# CHABAD CENTER FOR MISSION HILL

1615-1617 Tremont Street

Architectural Conservation District Commission

Design Review Application – Revised from March 7 Design Review

Proposed Design: February 14, 2024

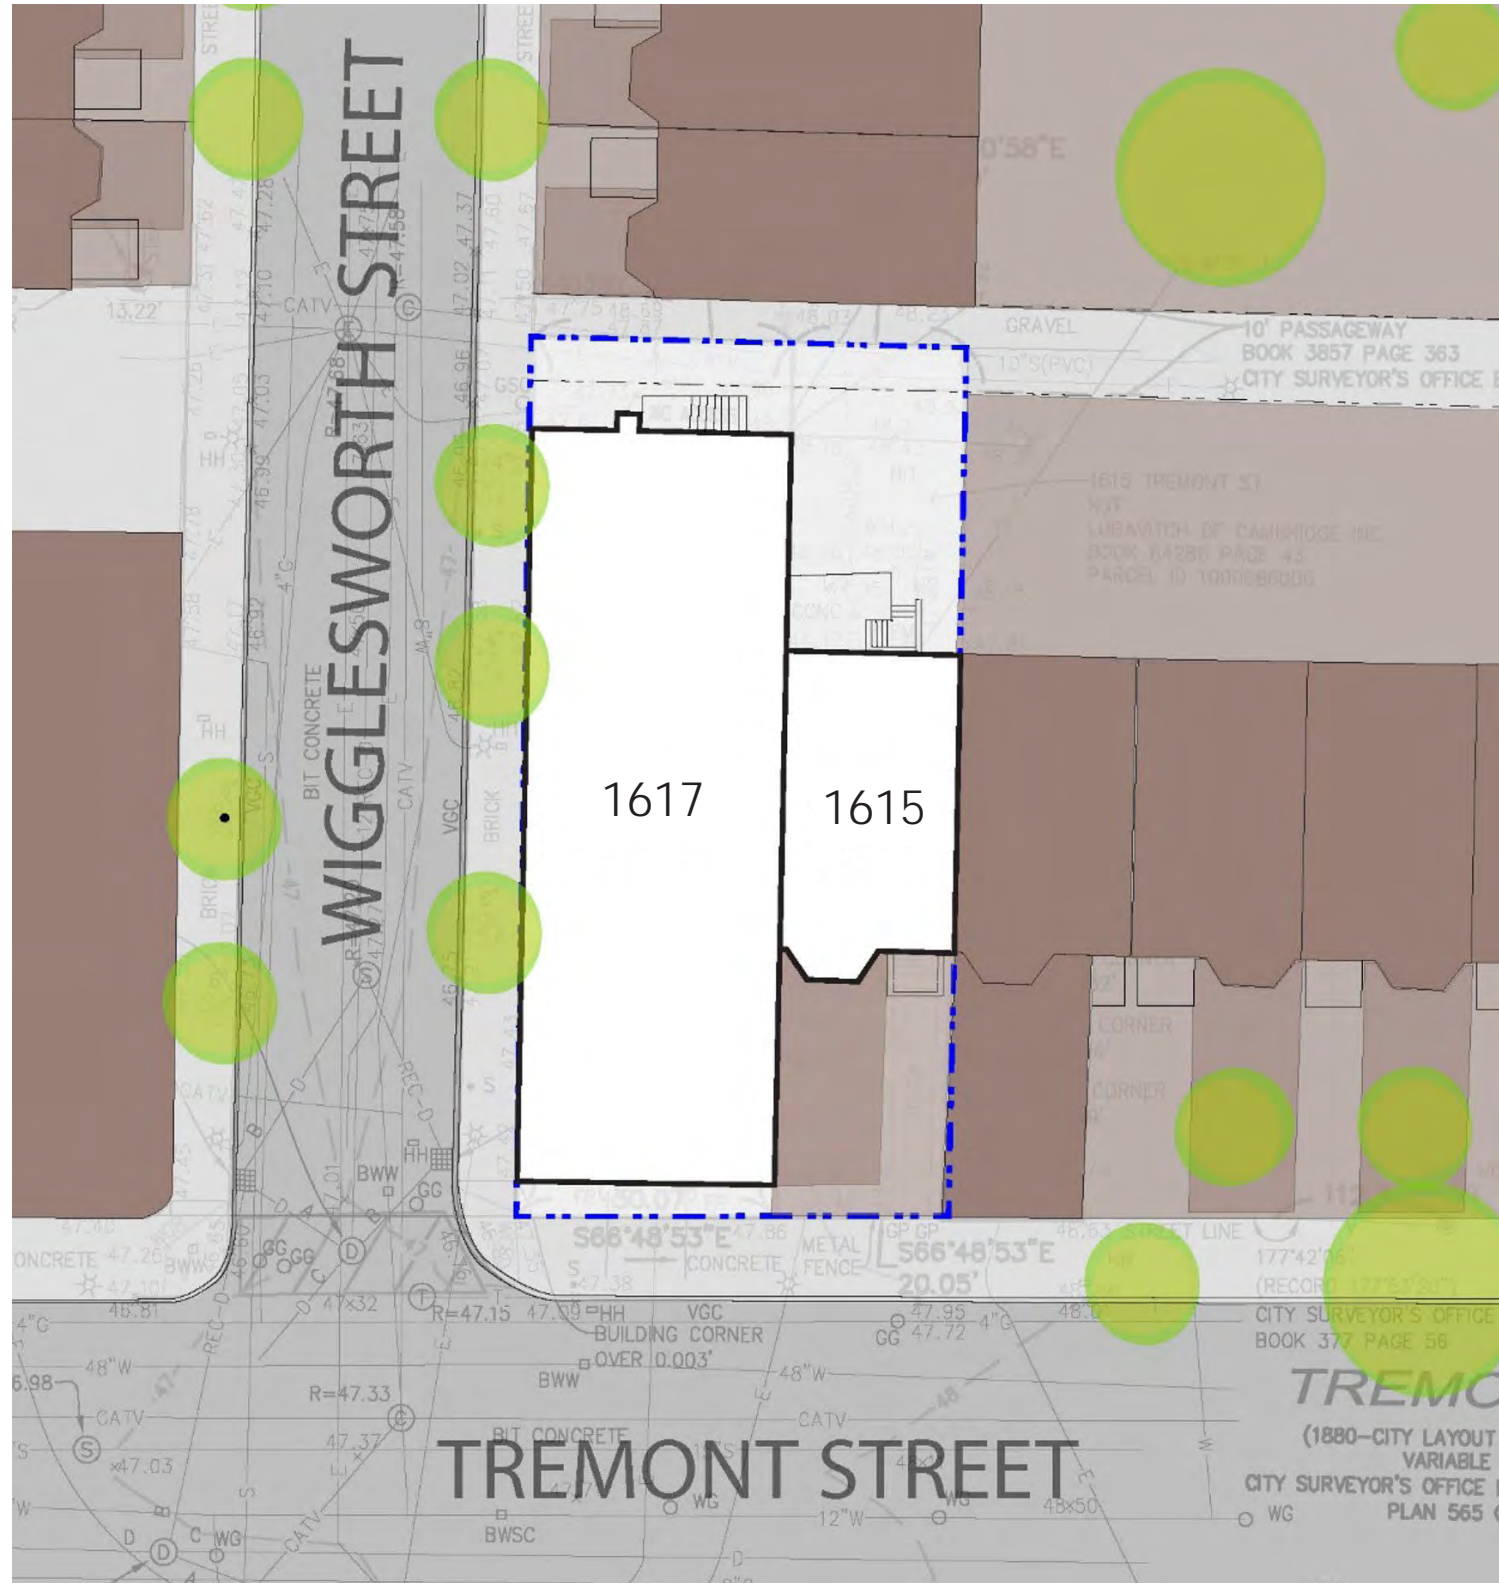
- Note a concern about the new building height and massing, and more generally noted that the proposed building seems “non-conforming when compared to other buildings”.
- Request design modifications to “reflect a better harmony between the two buildings so that its introduction into such a small, mainly residential district is less jarring.”
- Request more information regarding the design on the alley side.
- Requested rendered views without trees.

Proposed Design: April 4, 2024

## Street Views

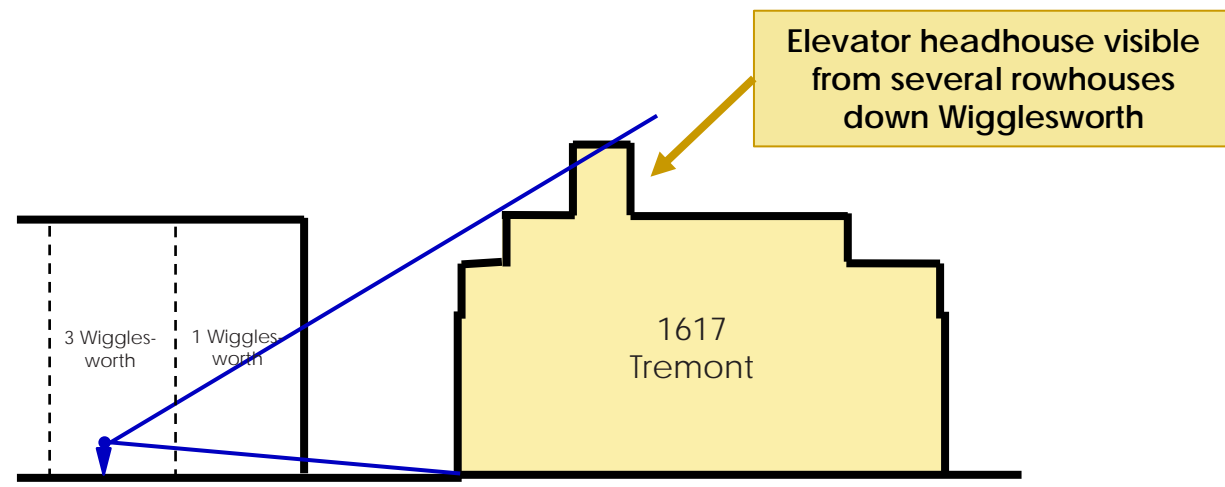
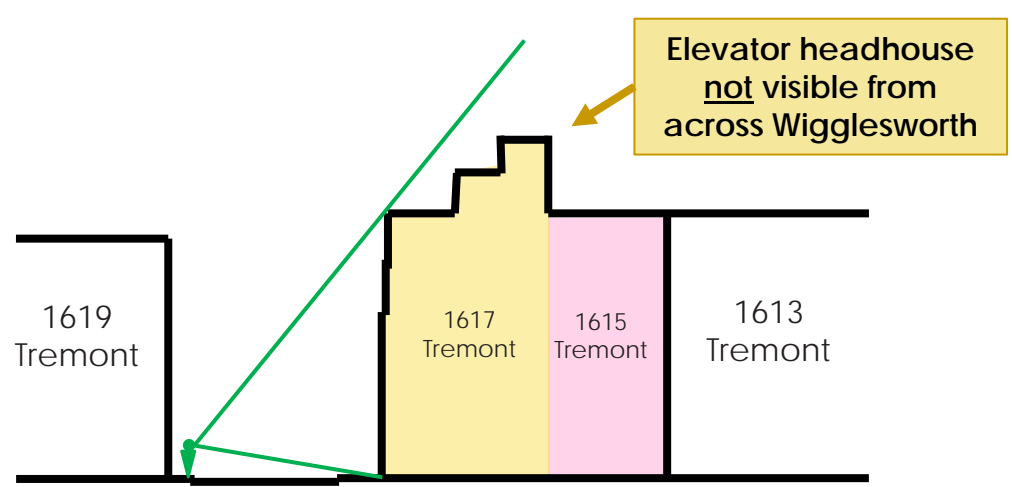
Elevator headhouse visible from several rowhouses down Wigglesworth

4<sup>th</sup> flr Step backs strengthen vertical hierarchy of massing

Recesses at wall to break down scale along Wigglesworth St.

4<sup>th</sup> flr Step backs strengthen vertical hierarchy of massing (18') from property line

Adjusted Roof Terrace Railing to less visible

Street View – Standing Across Tremont, Looking North

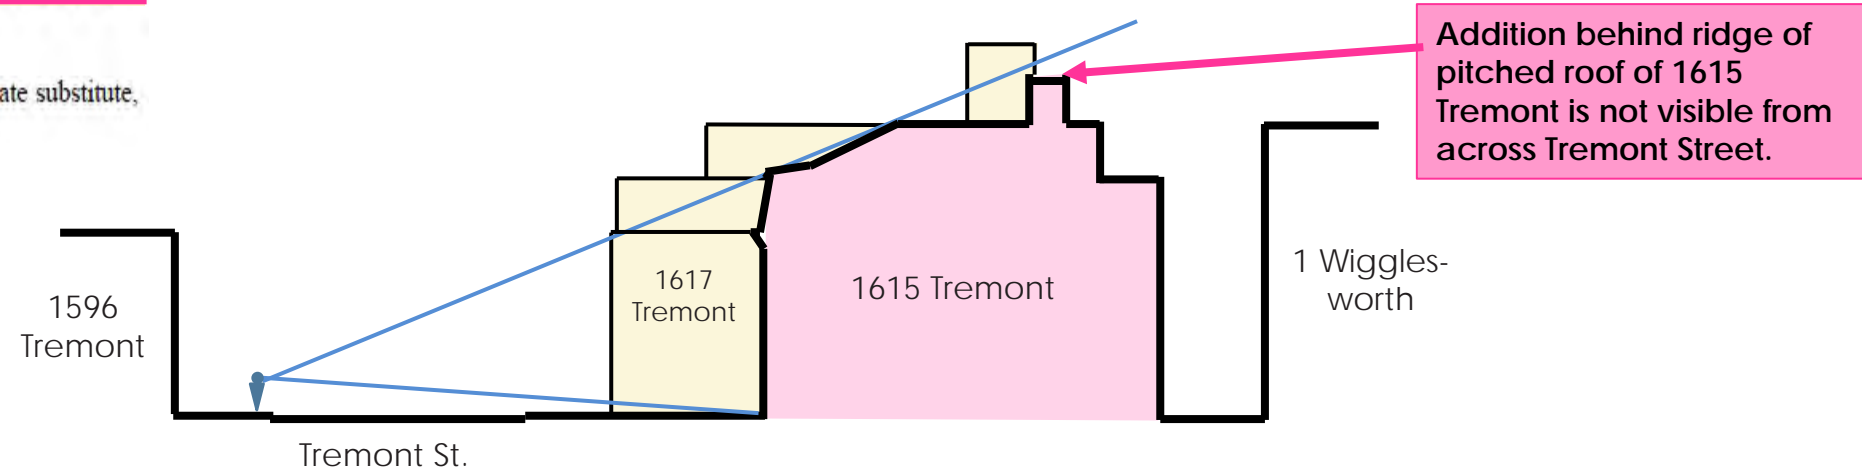
Guideline Section E requires vertical addition to not be visible behind ridge line of pitched roof from the front of the building.

4<sup>th</sup> flr Step backs strengthen vertical hierarchy of massing (18') from property line

Adjusted Roof Terrace Railing to less visible
